ACCESS REPORT

PROJECT: Ulladulla Public School upgrade
PROJECT NO: GDL240199
PREPARED FOR: Department of Education (DoE)
REVISION: H
DATE: 25.03.2025

This Access Consultant 100% Schematic Access Report has been prepared to support a Review of Environmental Factors (REF) for the NSW Department of Education (DoE) for the Ulladulla Public School upgrade (the activity).

01

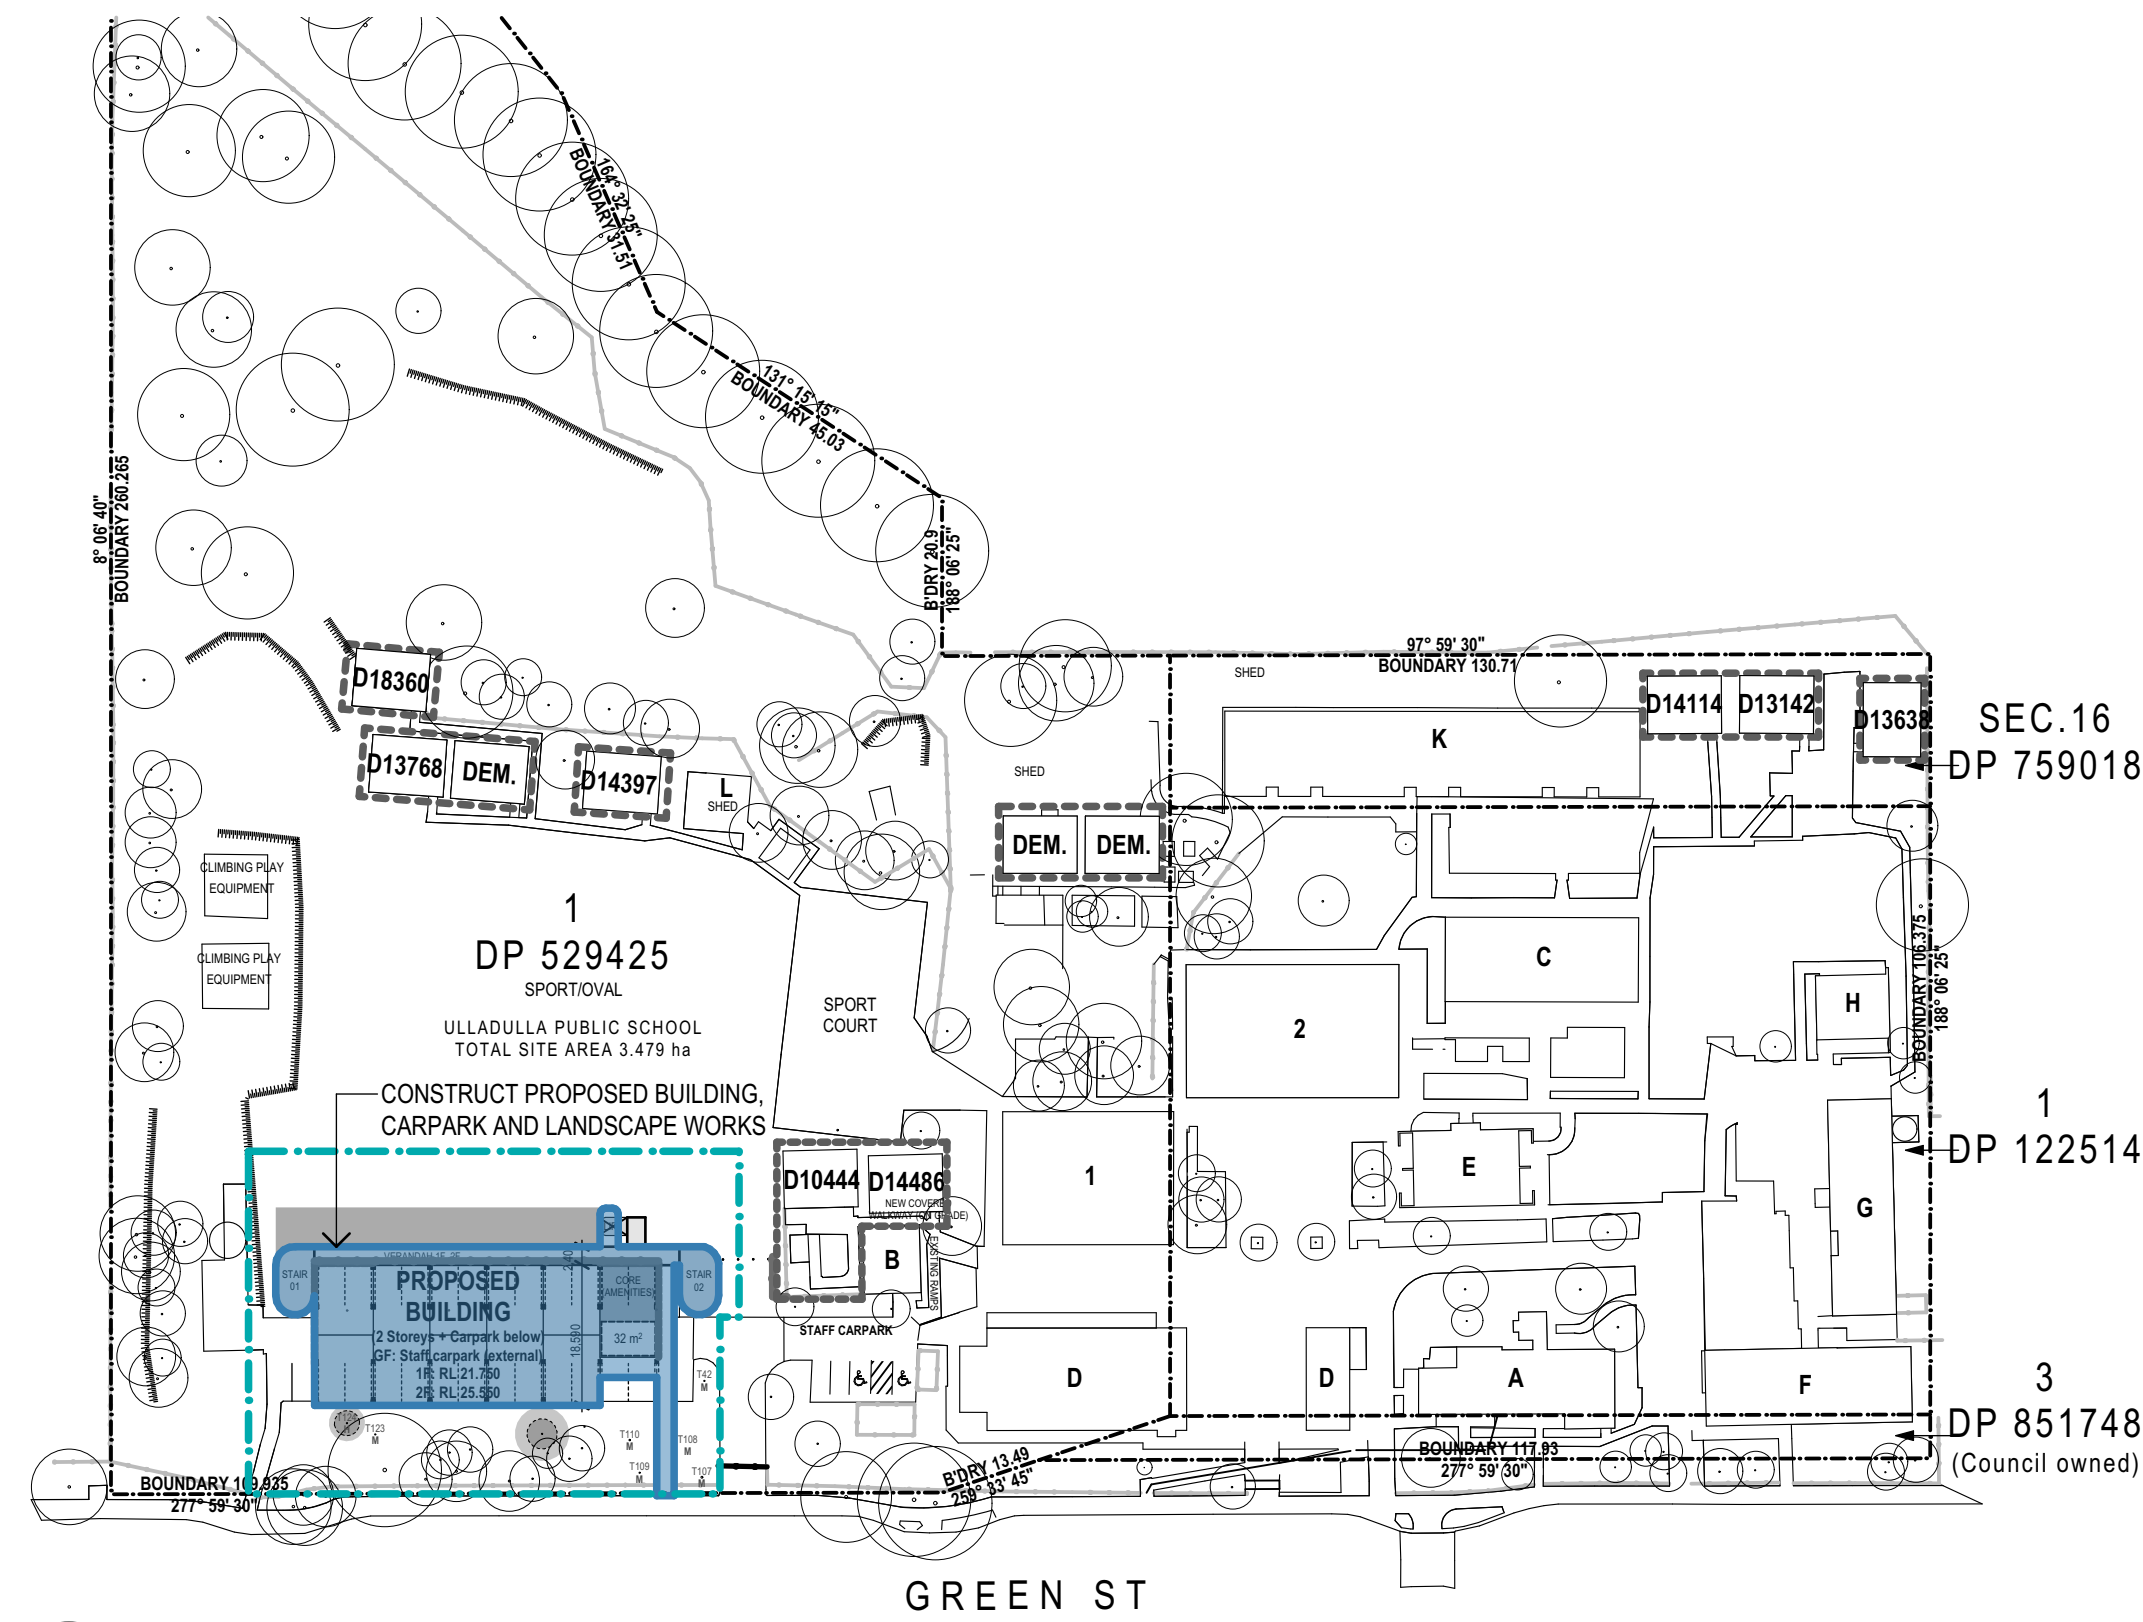
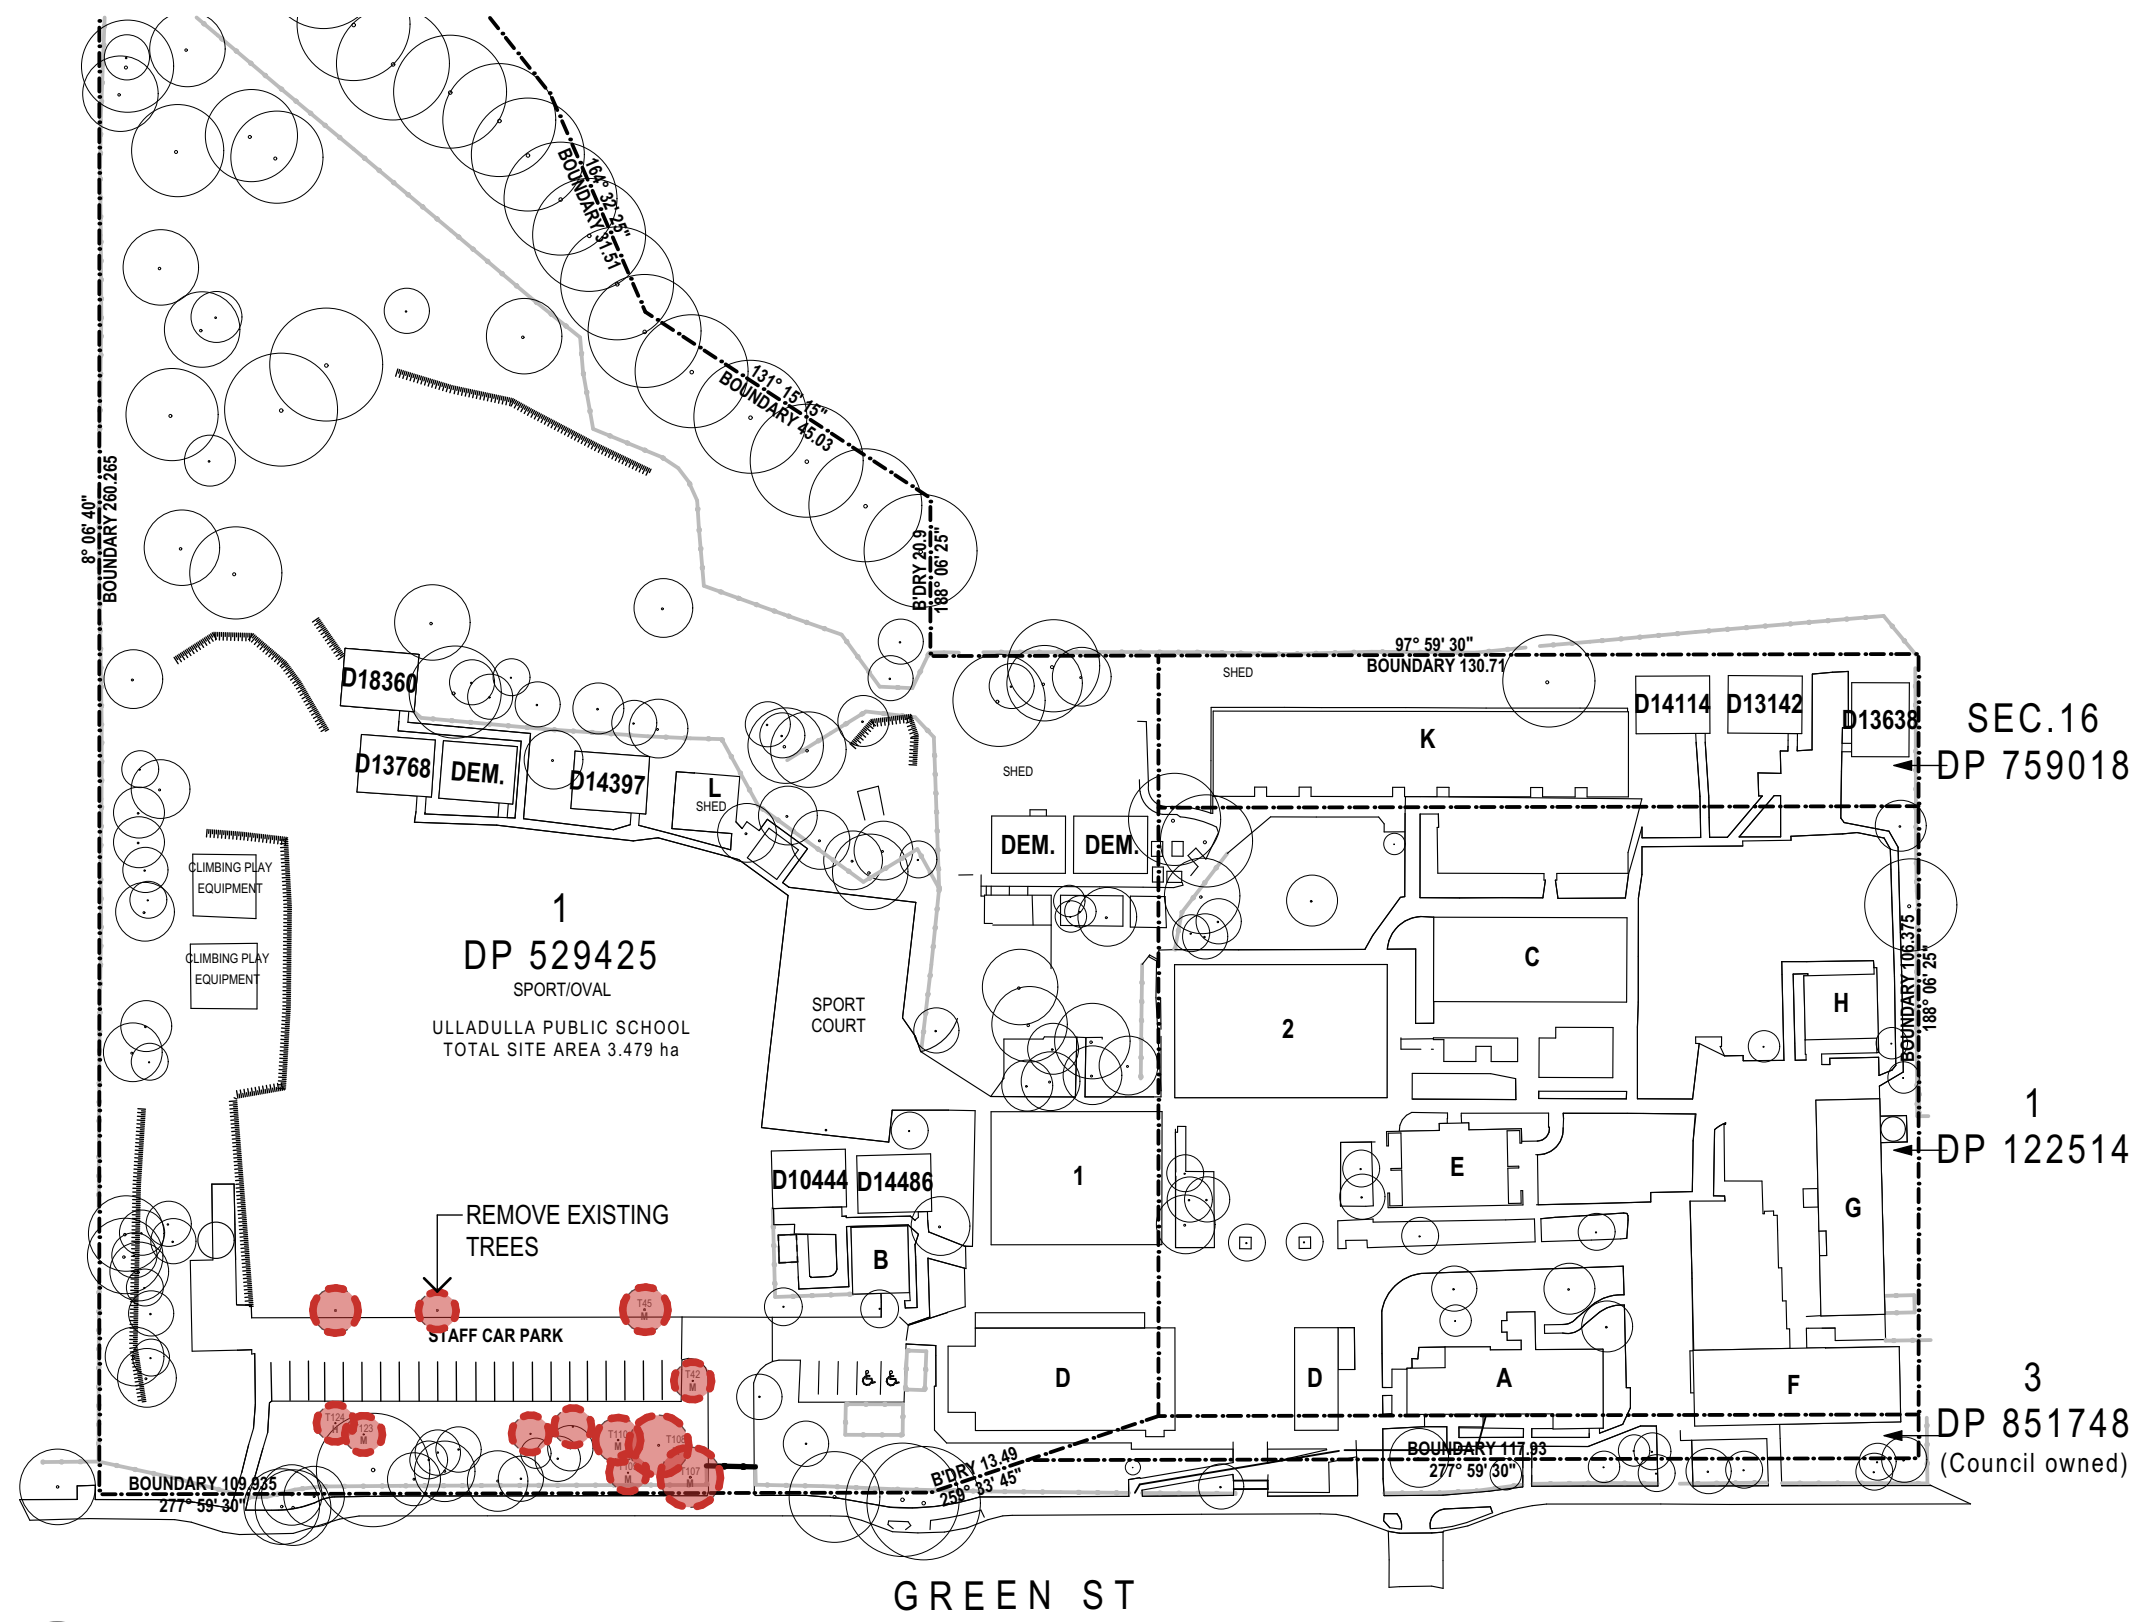
DETAILED SURVEY TO THESE TWO EXISTING
RAMPS TO BE PROVIDED. MAKE ALLOWANCE
FOR MINOR UPGRADES TO EXISTING RAMPS
AND LANDINGS TO MEET COMPLIANCE TO THE
GREATEST EXTENT POSSIBLE (EG. NEW
HANDRAILS, TGS, LOCALISED REGRADING
TO REMOVE TRIP HAZARDS ETC).

1 PLAN
INDIGENOUS ARTWORK STRATEGY
SCALE: 1:100

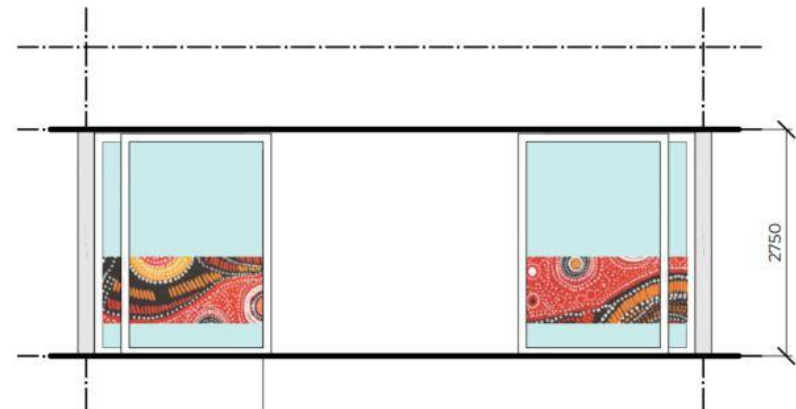
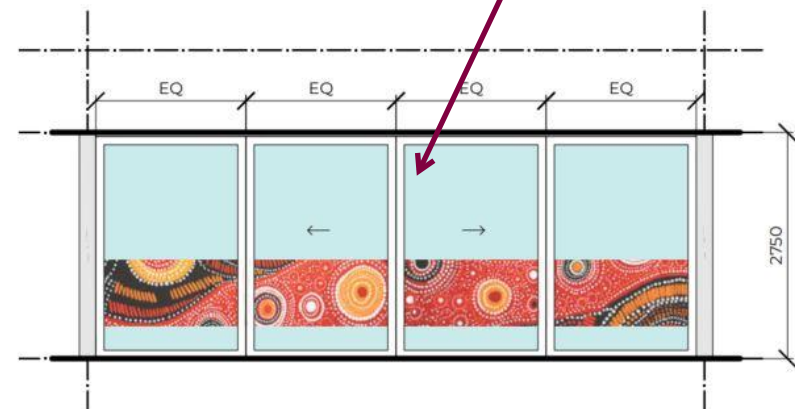
GDLA_DDA_6
Artwork decals to
provide minimum
30% luminance
contrasts to surface
within 2M beyond the
glazing

**PROPOSED LOCATIONS FOR
INDIGENOUS ART WORK - EXTERNAL:**

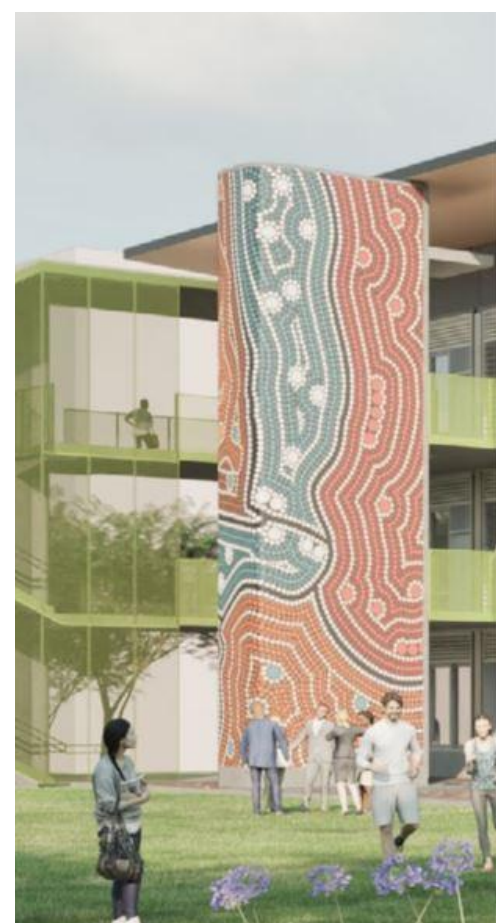
GDLA_DDA_7
For ease of navigation in the new works, it is
highly recommended that decals on glazings
that are adjacent to entry doors are to be clearly
distinguishable from those used on glazed
doorways, so to not cause confusion.
